Access Compliance Report

Public Rights-of-Way

(Curb Ramps)

Intersection ID: 47841	Main Street: MANITOBA_LN	Cross Street: ALVARADO_WY	Location: SE
ADA ID: 93127778A2C5	Ramp Type: PerpDiag	Initial Pass/Fail: Fail	Overall Compliance: No
Severity Score: 8.75			
Codes/Mitigation Info/Possible Solution		Field Measurements/Component Compliance

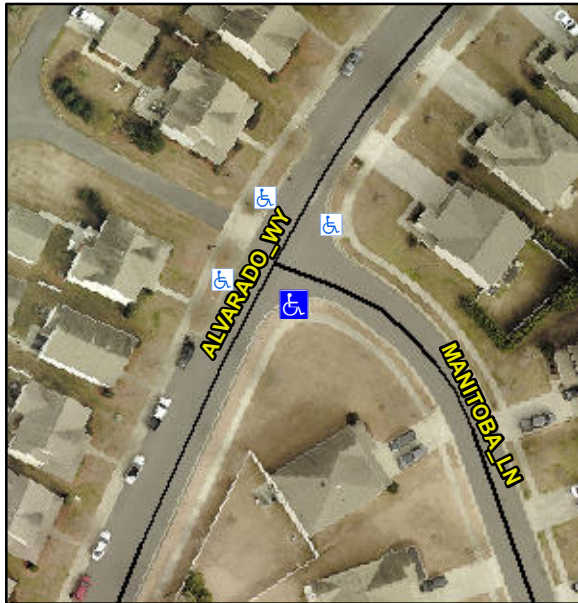
Compliance	Description	Data	Compliance	Description	Data
N/A	Ramp Length (in)	135.0	Yes	Ramp Slope (%)	7.8
No	Ramp Width (in)	46.0	Yes	Ramp XSlope (%)	1.6
N/A	Flare Type LT	N/A	N/A	Flare Type RT	N/A
N/A	Flare Slope LT (%)	N/A	N/A	Flare Slope RT (%)	N/A
N/A	Flare Traversable LT?	N/A	N/A	Flare Traversable RT?	N/A
N/A	Landing Length (in)	N/A	N/A	DWS Provided?	N/A
N/A	Landing Width (in)	N/A	N/A	DWS Contrast?	N/A
N/A	Landing Slope (%)	N/A	N/A	DWS Length (in)	N/A
N/A	Landing X Slope (%)	N/A	N/A	DWS Full Width?	N/A
N/A	Landing Curb? (Y/N)	N/A	N/A	DWS Offset (in)	N/A
N/A	Shared Landing?	N/A			
N/A	Gutter Ponding?	N/A	N/A	Gutter Slope (%)	N/A
N/A	Gutter Lip Ht (in)	N/A	N/A	Gutter X Slope (%)	N/A
N/A	Painted X Walk1?	No	N/A	Painted X Walk2?	No
	X Walk 1 Direction	To NE		X Walk 2 Direction	To NW
N/A	X Walk 1 Width (in)	N/A	N/A	X Walk 2 Width (in)	N/A
	X Walk 1 Slope (%)	1.5		X Walk 2 Slope (%)	1.7
	X Walk 1 X Slope (%)	0.1		X Walk 2 X Slope (%)	1.1

Remove & Replace Curb Ramp With Two New Directional Ramps or Equivalent.
